CITY PLANNING COMMISSION
 1231 "I" STREET, SUITE 200, SACRAMENTO, CA. 95814

APPLICATION: A. Negative Declaration

B. Special Permit to develop a 178 unit apartment complex on 8.85± vacant acres in the Multi-Family Planned Unit Development (R-2B PUD) zone and within the Laguna Meadows PUD

LOCATION: Southwest corner, Jacinto Avenue and Bruceville Road

SITE STUDY

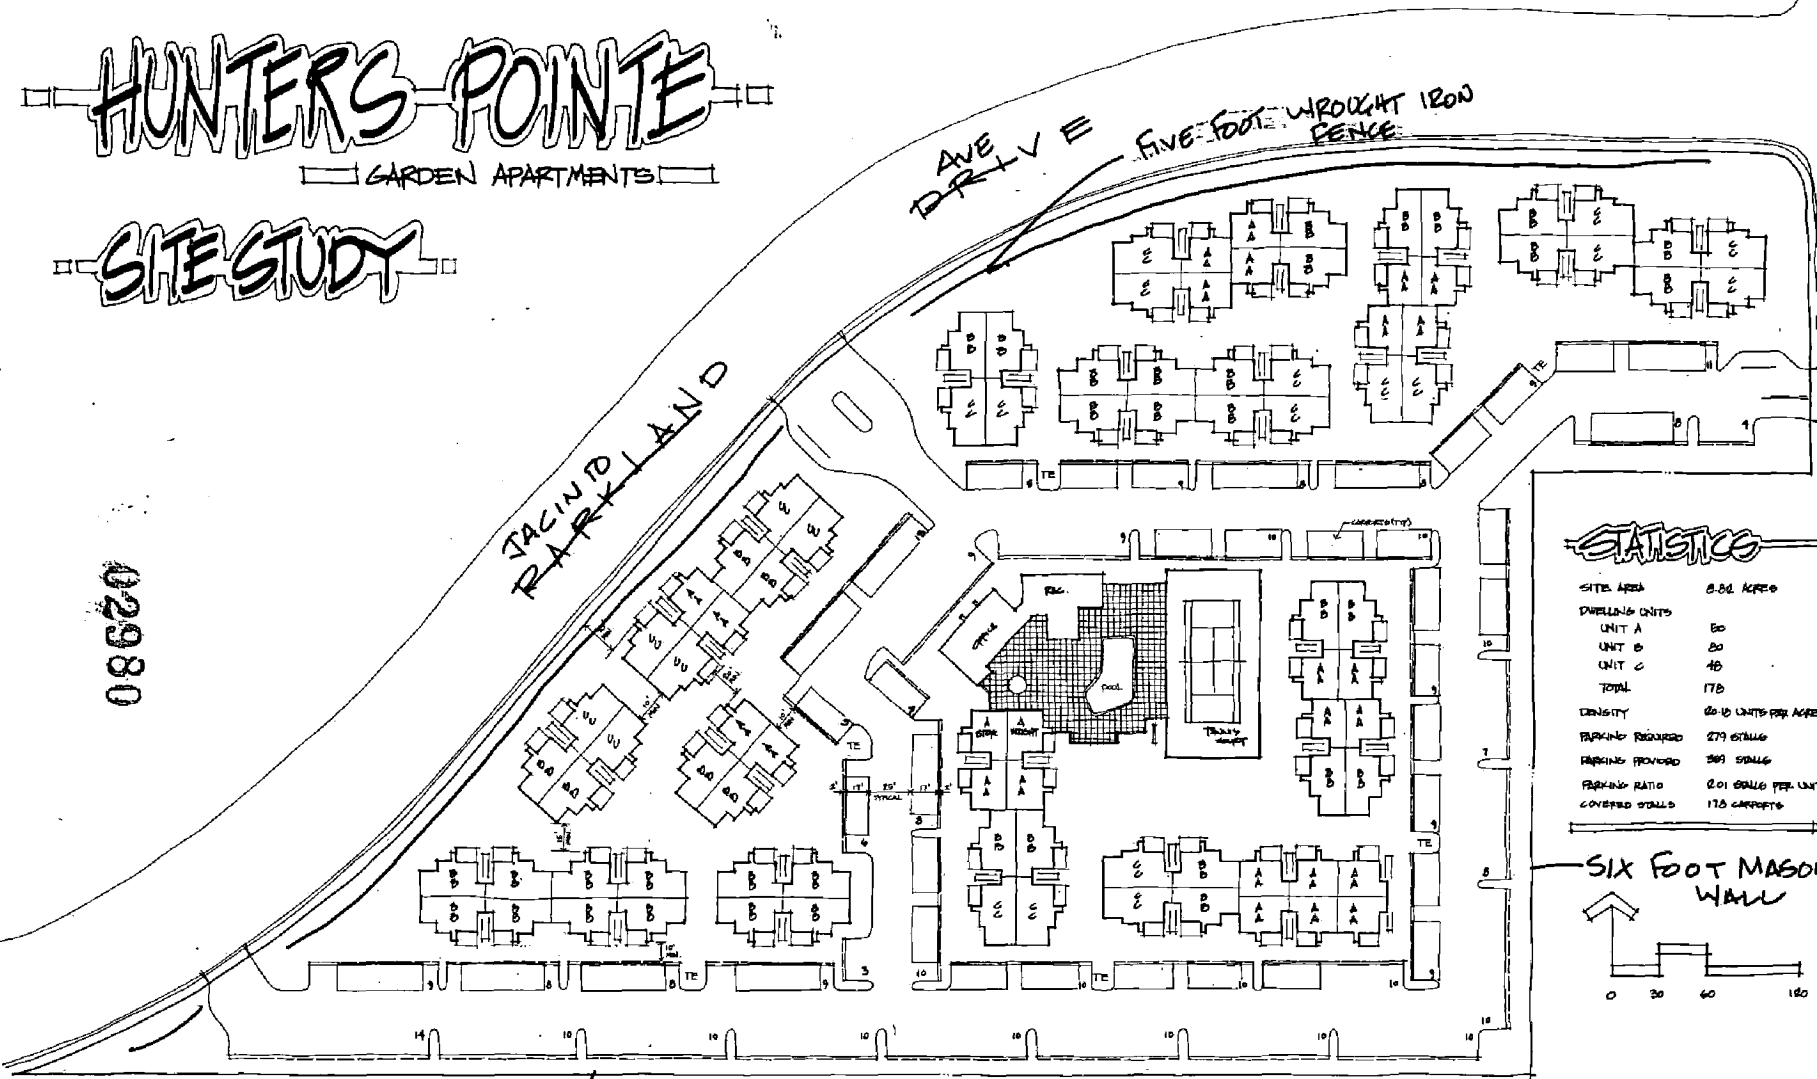
The submitted site plan indicates thirteen building clusters consisting of three unit types. Proposed unit breakdown is as follows:

Buildings are two-story consisting of eight or sixteen units per building. Proposal includes pool, recreation center, tennis courts and tot lot.

Access into the project is from both Jacinto Avenue and Bruceville Road. Based on the PUD parking standards, 279 parking stalls are required. The applicant has provided 359 stalls, of which 178 are to be covered in carports. The PUD and zoning ordinance requires a six foot decorative masonry wall on interior property lines between parking lot areas and existing or proposed residential development.

1. Maximum Driveway width is 35 feet.
2. Medium Islands in driveway will be a minimum of 20 feet back of property line.
3. Access on Bruceville will be right in/right out only.
4. Remove turn-out at entrance of main driveway.

1. A master plan for construction of public improvements of all parcels within the Laguna Meadows PUD is required prior to approval.
2. Comply with PUD Guidelines.
3. Align main entrance with street in Laguna Verde Subdivision (P88-220).

1. The applicant shall submit a revised site plan to planning staff for review and approval prior to issuance of building permits.
2. The applicant shall construct a six (6) foot decorative masonry wall along the south and east property lines adjacent to proposed and existing single family development. The design of the wall shall be reviewed and approved by staff prior to issuance of building permits.

9. Access on Bruceville Road shall be right in/right out only.
10. Applicant shall align main entrance with street in Laguna Verde Subdivision.
11. Building plans shall be to the satisfaction of the City Fire Division.

PRELIMINARY LANDSCAPE PLAN

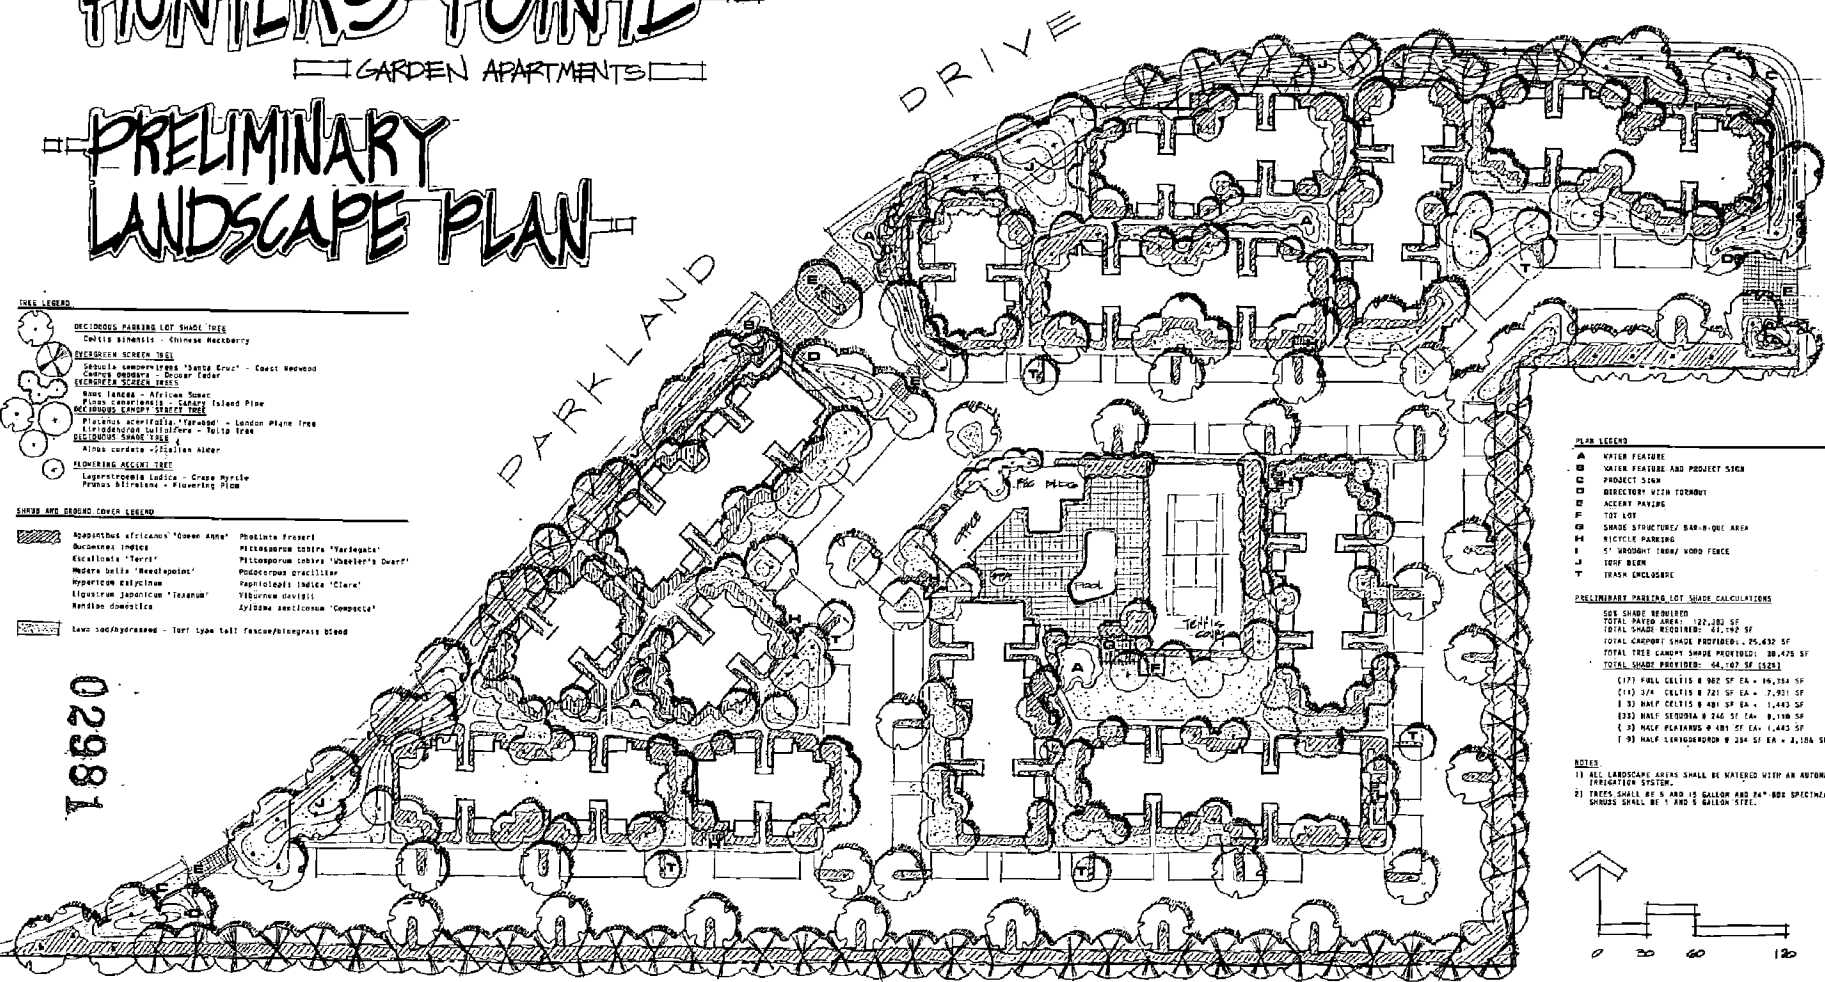
Planning staff also suggests locating a 5 foot high decorative wrought iron fence along the entire length of the Jacinto Avenue frontage. The use of the wrought iron fence will discourage on-street parking by project residents. The submitted landscape plan illustrates this wrought iron fence. The landscape plan indicates the use of contrasting paving materials at the entrances. Staff wants to note that this paving must meet Zoning Ordinance requirements. Staff suggests the use of stamped concrete or boumanite in these areas. The submitted preliminary landscape looks acceptable. However, staff needs to review and approve the final landscape plan prior to issuance of building permits.

3. The applicant shall construct a five (5) foot decorative wrought iron fence along the entire Jacinto Avenue frontage.
4. Trash enclosures and bicycle storage facilities shall conform to the City's Zoning Ordinance.

5. A final landscape plan shall be submitted for review and approval by Planning staff prior to issuance of building permit.
6. The building elevations shall consist of cement plaster, individual 4 inch wood siding with concrete tile roofing material or equivalent to be approved by staff. Revised elevations shall be submitted for staff review and approval prior to issuance of building permits.

HUNTERS POINTE
 GARDEN APARTMENTS

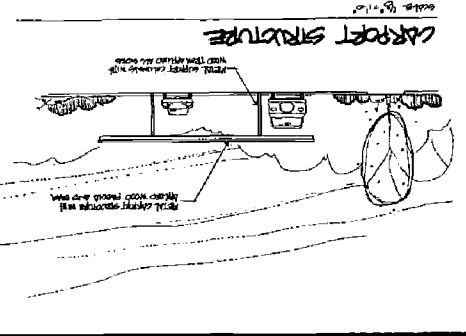
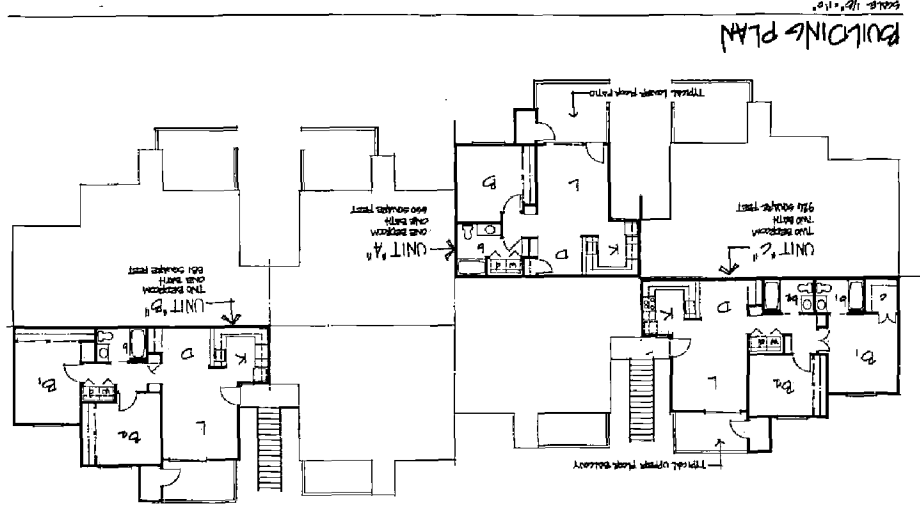
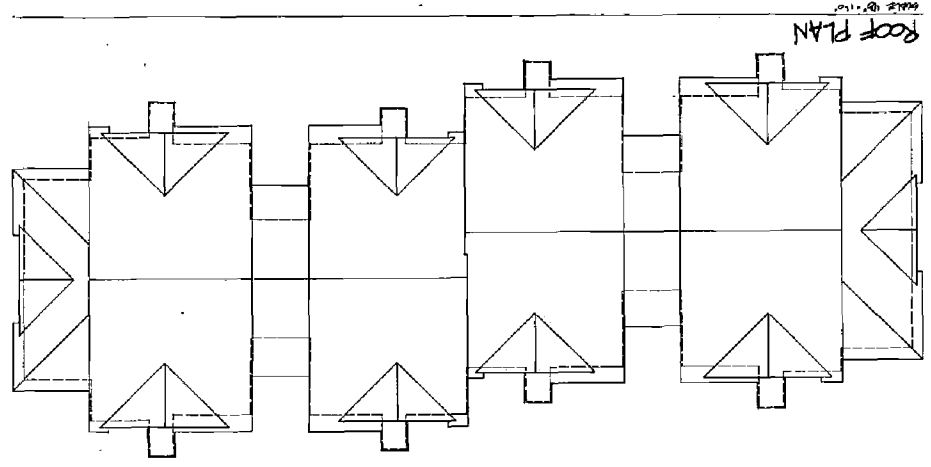
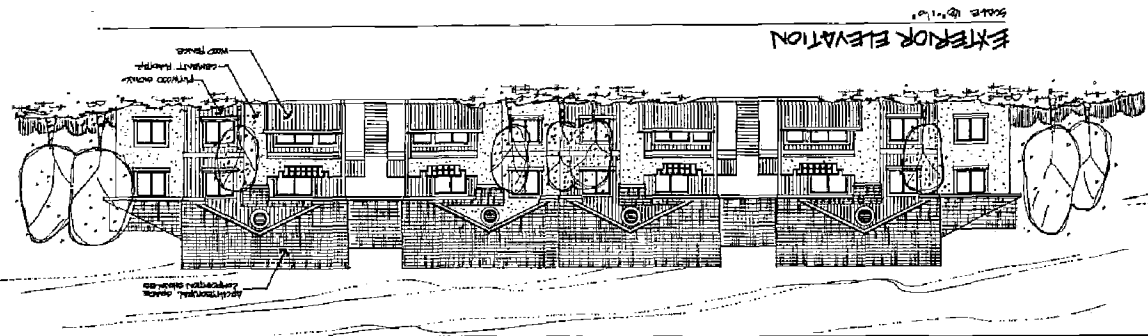
The applicant proposes building exteriors consisting of cement plaster and plywood siding with composition shingle roofs. Staff has some concerns with the quality of the exterior materials. Staff had stated these concerns in the preliminary review prepared for this project. Staff recommends the following revisions to the elevations:

- * 4 inch horizontal wood siding should be utilized instead of the proposed plywood siding.
- * Patio fencing should be compatible with the horizontal wood siding on the main structures.
- * Roofing material should be concrete tile or equivalent approved by staff prior to issuance of building permits.
- * Carports should be compatible in design with main buildings. Flat roofs are discouraged in the PUD Guidelines. Staff suggests pitched roof or other roof variation.

The applicant should submit revised building elevations for review and approval by Planning staff prior to issuance of building permits.
